General Bid Bulletin No. 11
30 June 2021

**THE MALOLOS-CLARK RAILWAY PROJECT AND THE NORTH-SOUTH RAILWAY
PROJECT SOUTH LINE COMMUTER PACKAGE CP NS-01: PROCUREMENT OF
ELECTRICAL AND MECHANICAL SYSTEMS AND TRACK WORKS (IFB No: 21-040-3)**

This General Bid Bulletin is issued to amend/clarify certain provisions in the Bidding Documents for the above-mentioned Project. Please refer to the attached Annexes of this General Bid Bulletin for details:

NSRP SOUTHLINE
 SCHEMATIC DIAGRAM
 SHEET 1

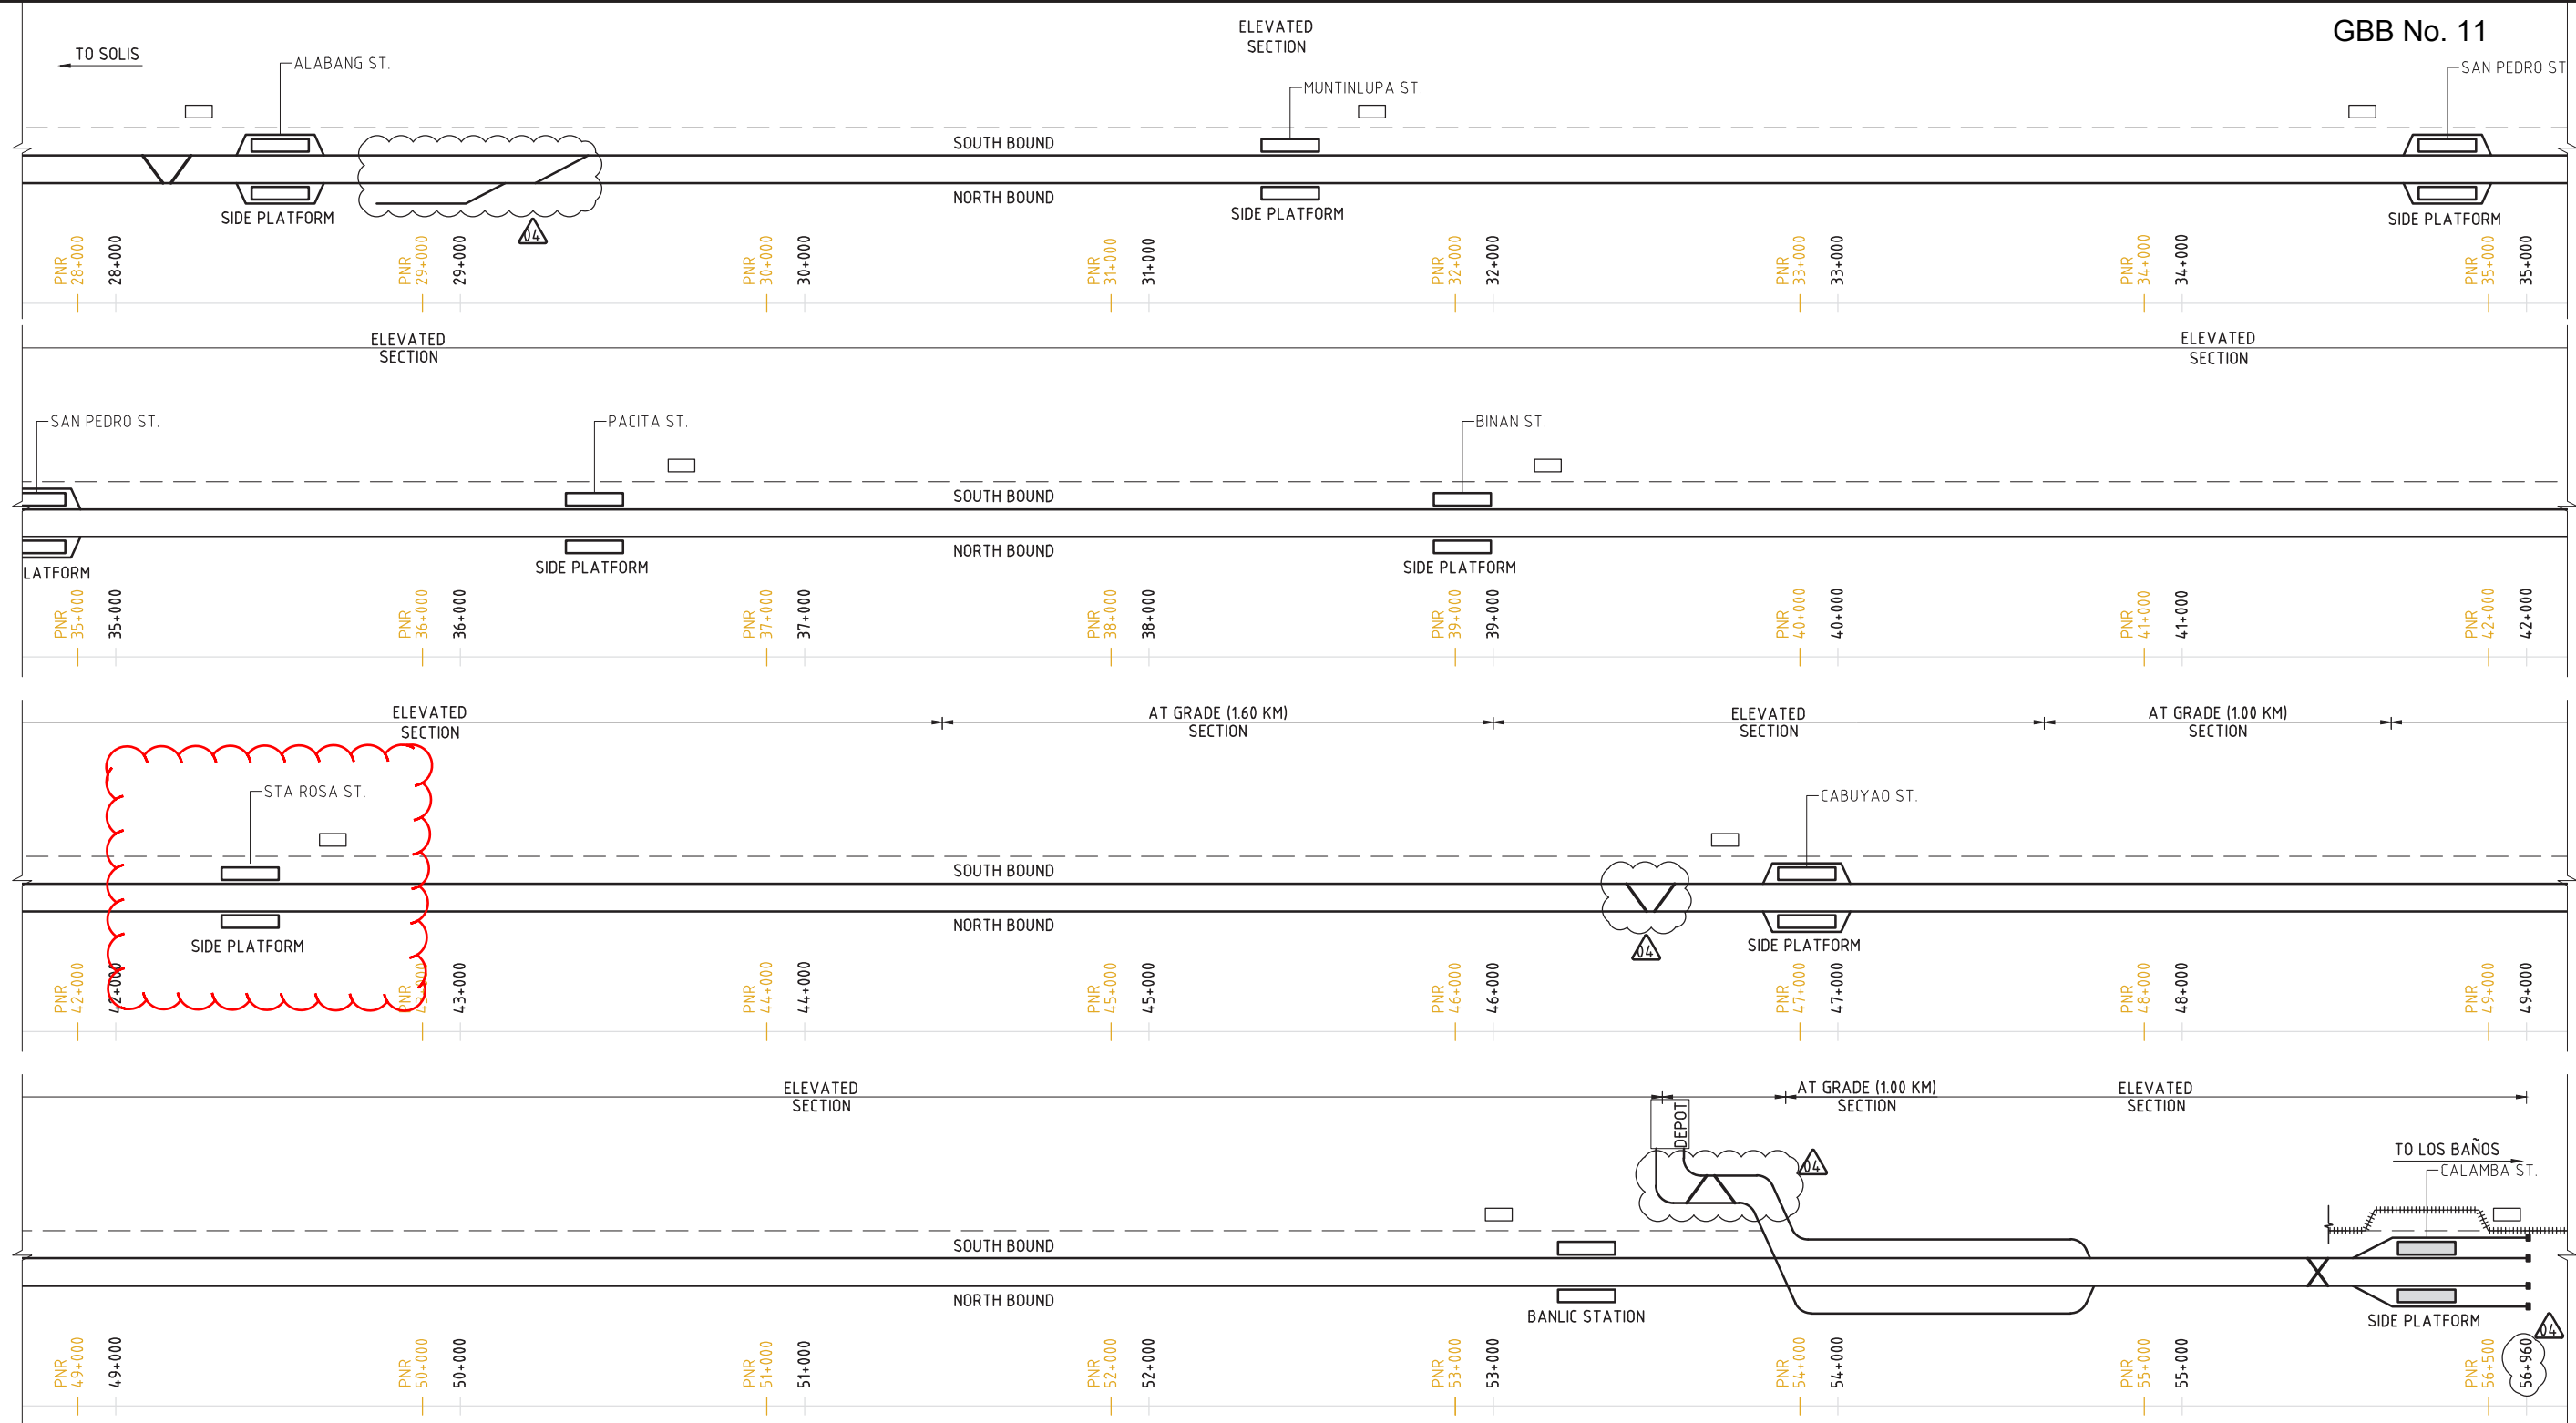
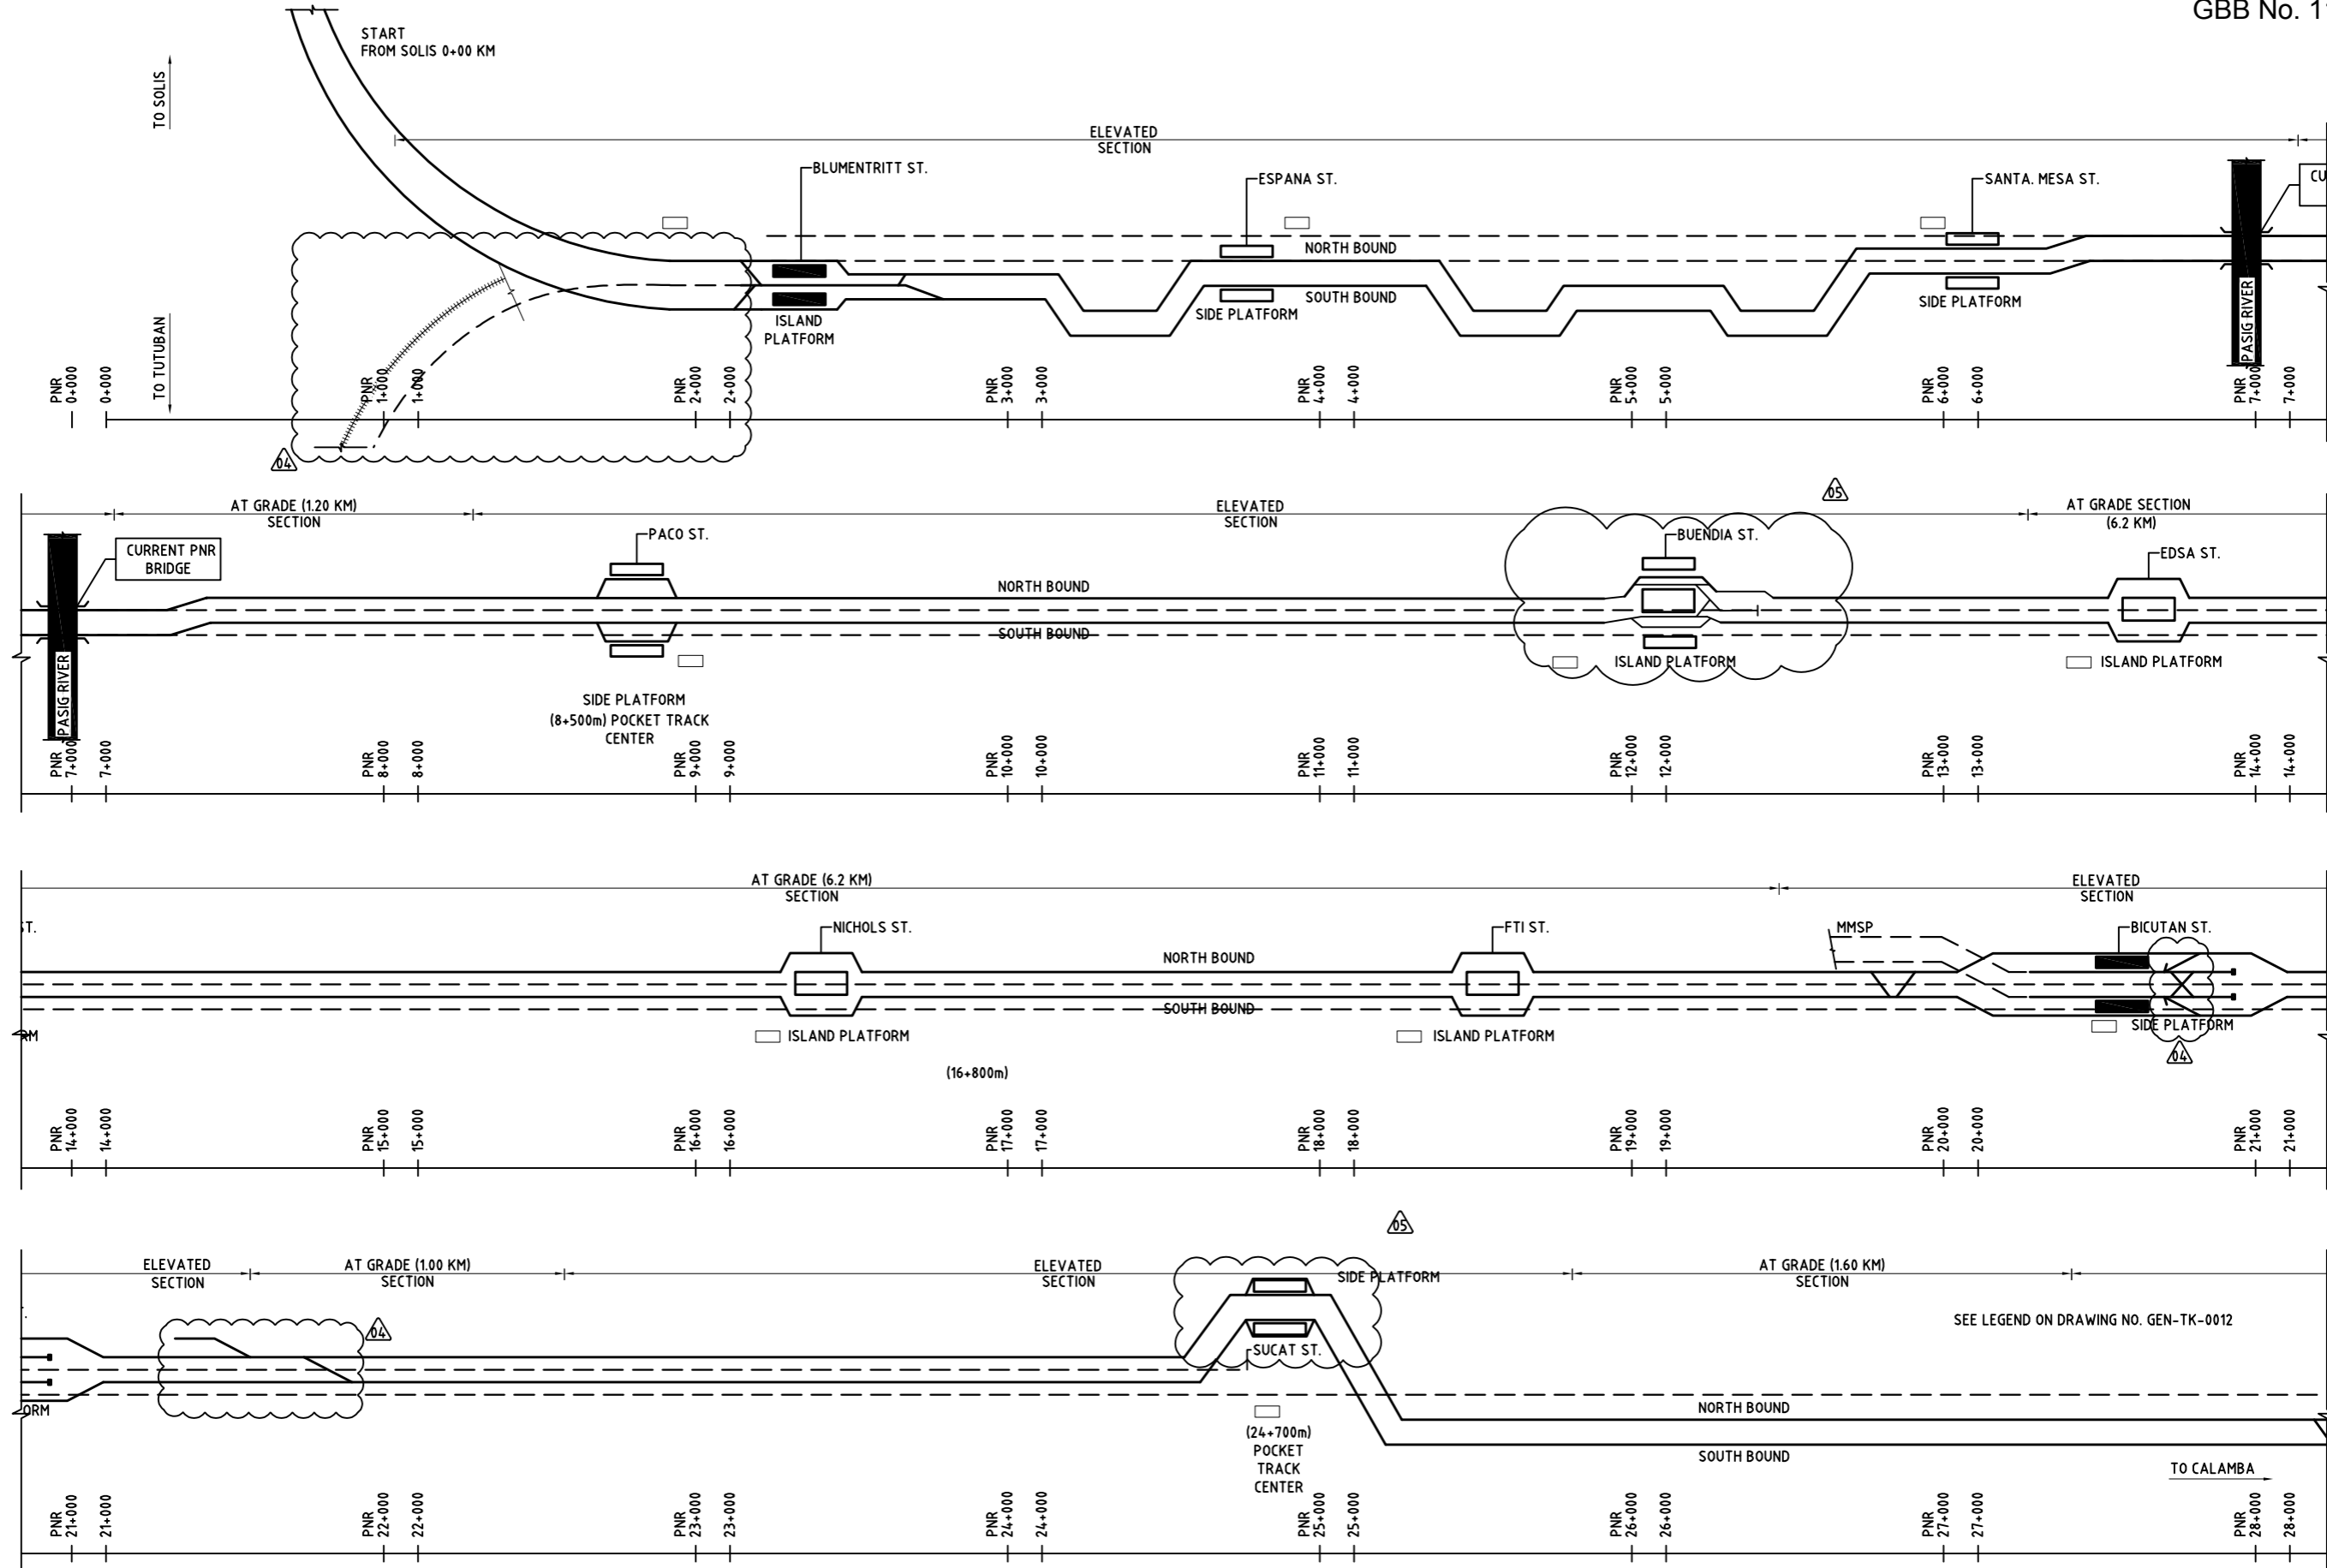
VERSIONS	DATE	DESCRIPTION
03	15 MAY 2019	ISSUED FOR REFERENCE
04	17 JUN 2019	REVISED/ISSUED FOR REFERENCE
05	16 JUN 2021	BUENDIA AND SUCAT STATION REVISED

NSRP SOUTHLINE
 SCHEMATIC DIAGRAM
 SHEET 2

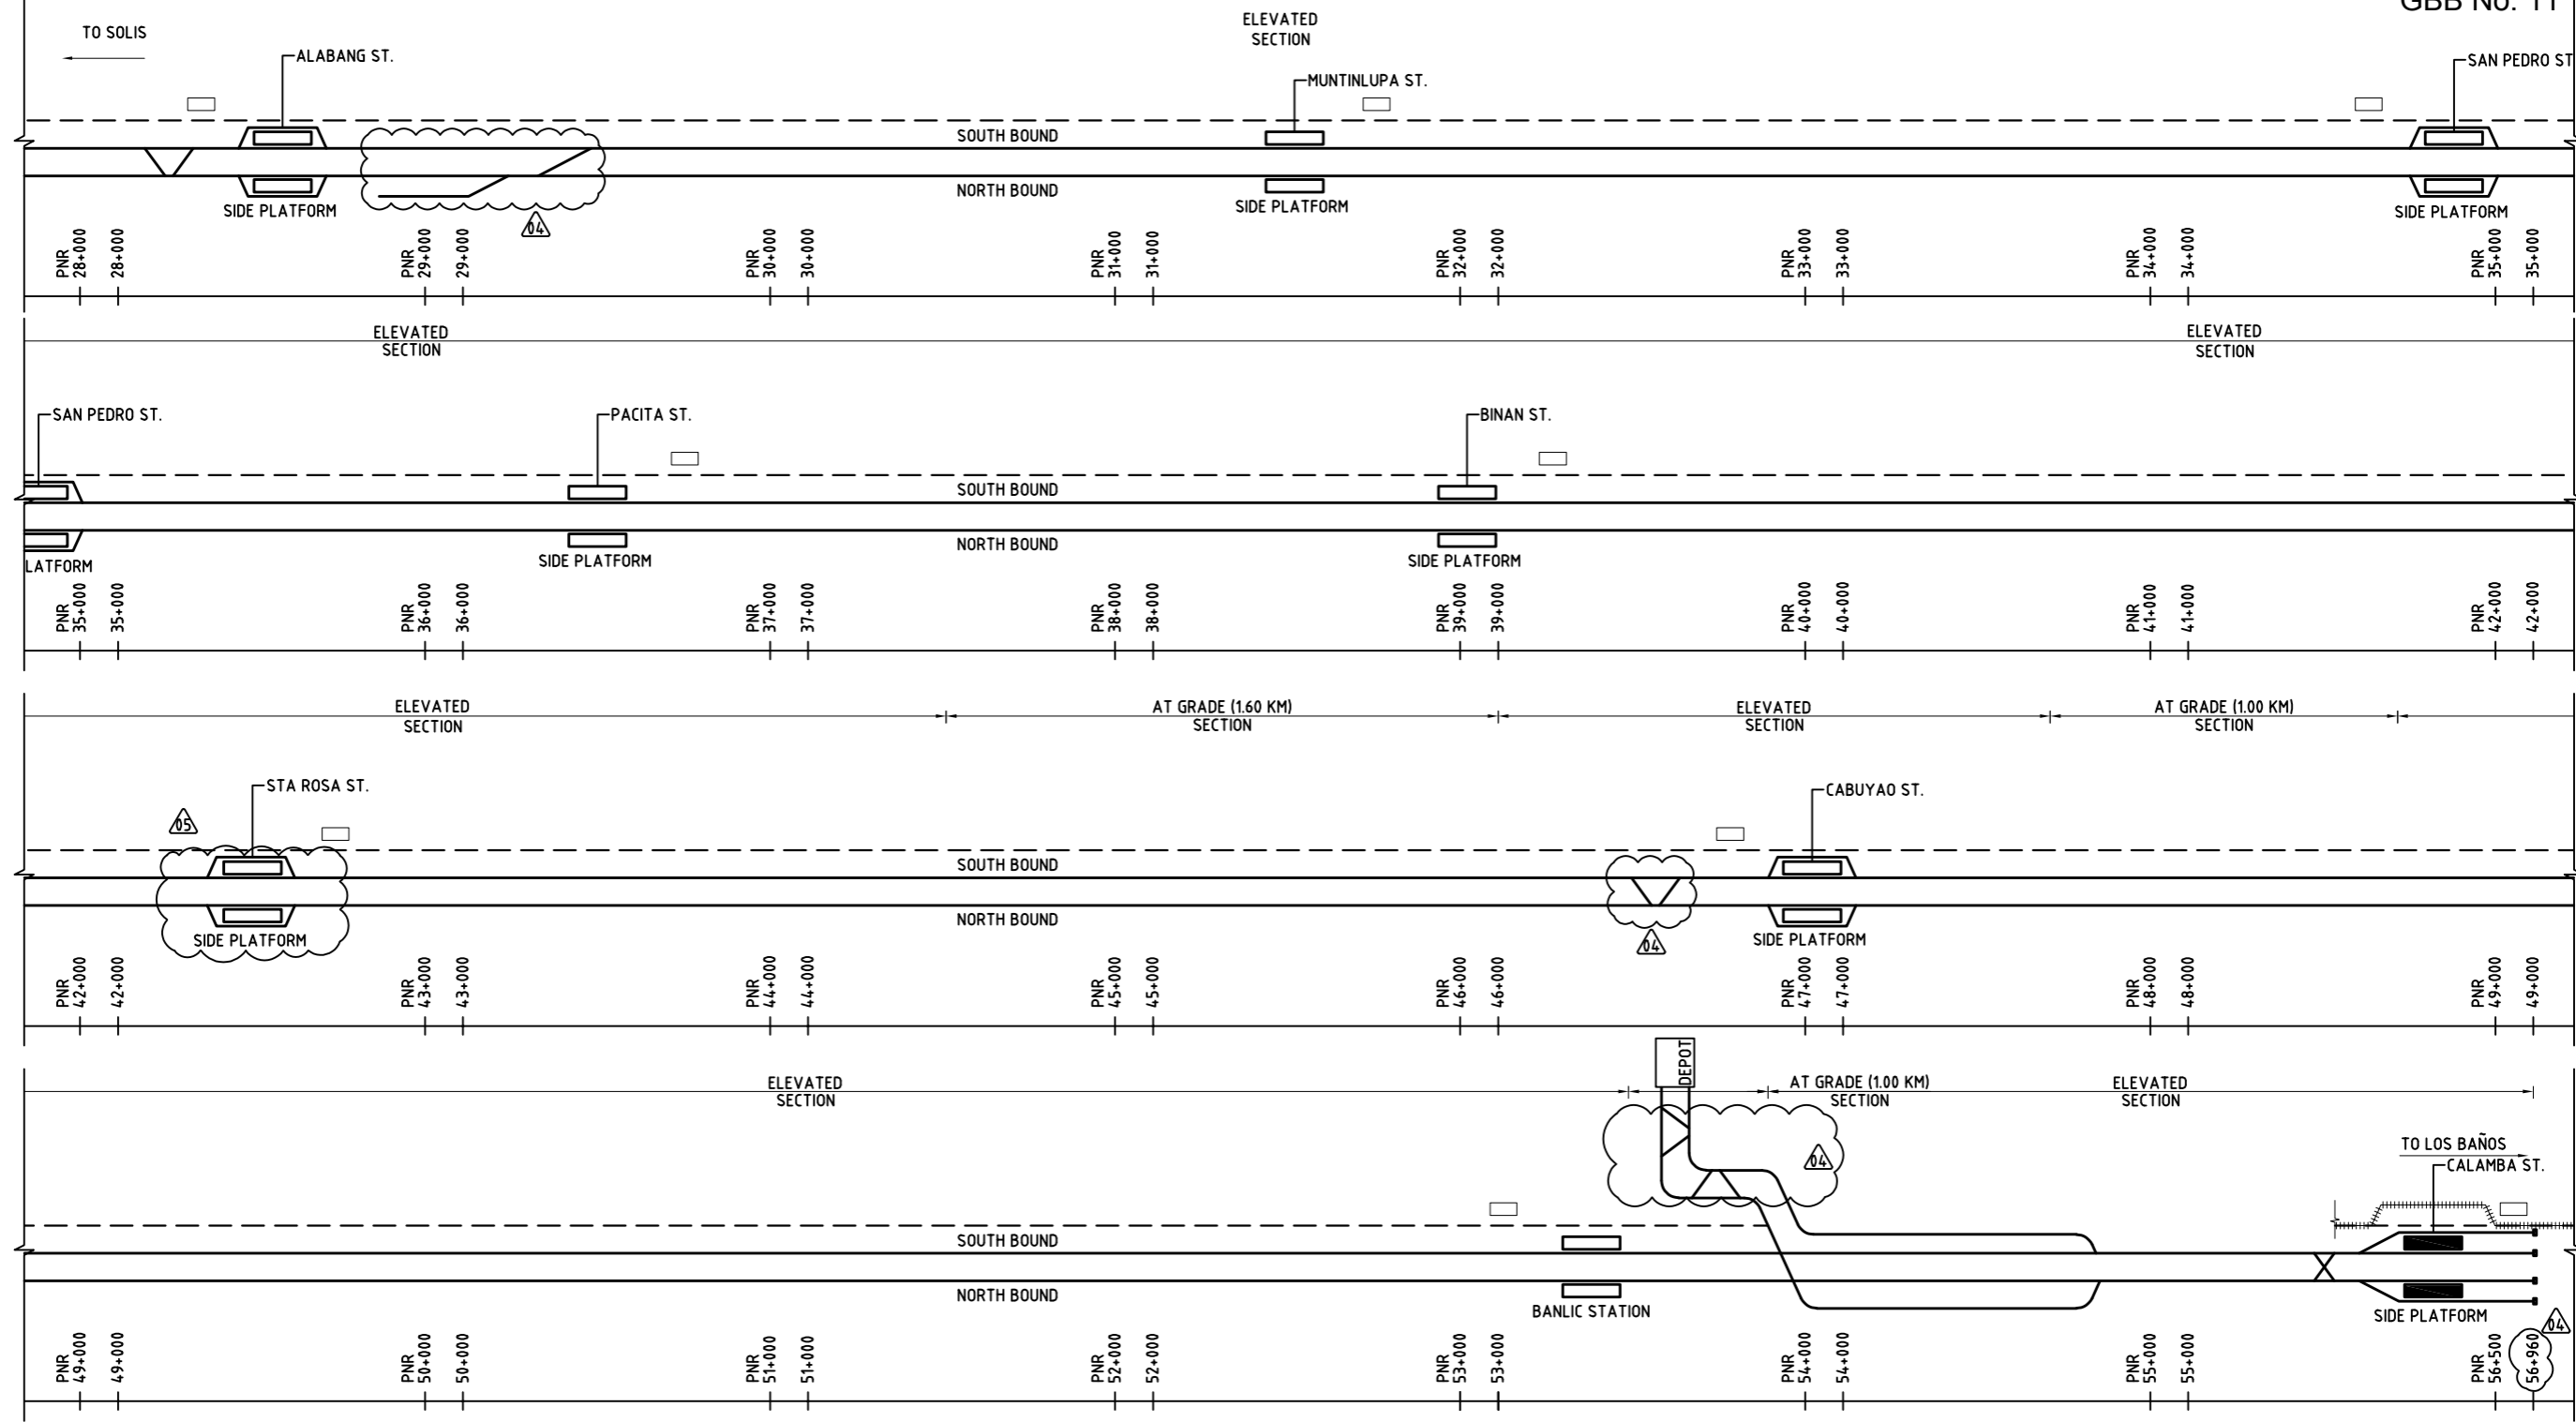
ITEM NO.	REFERENCE/CLAUSE/ SECTION	REVISIONS / AMENDMENTS
Volume II Part 2 – Employer’s Requirements		
1	ERT 18	Revised ERT 1.10.1 2) “The Contractor shall prepare the finished viaduct deck for the installation of the trackwork. The Contractor will be responsible for construction of the track bed concrete to a level 650 mm below proposed top of rail level to an unformed concrete finish.”
2	ERT 1041	Remove ERT 11.1.2.7
Volume III Part 2 – Employer’s Requirements d) Employer’s Drawings		
3	5a_CP NS-01BD Part2 Vol 3 NSRP-DWG-GEN-TK-0011	Revised Schematic drawing reflecting Buendia and Sucat Alignment future changes for Bidding reference only.
4	5a_CP NS-01BD Part2 Vol 3 NSRP-DWG-GEN-TK-0012	Revised Schematic drawing reflecting Sta. Rosa Alignment future changes for Bidding reference only.

VERSIONS	DATE	DESCRIPTION
03	15 MAY 2019	ISSUED FOR REFERENCE
04	17 JUN 2019	REVISED/ISSUED FOR REFERENCE
05	16 JUN 2021	SANTA ROSA STATION REVISED
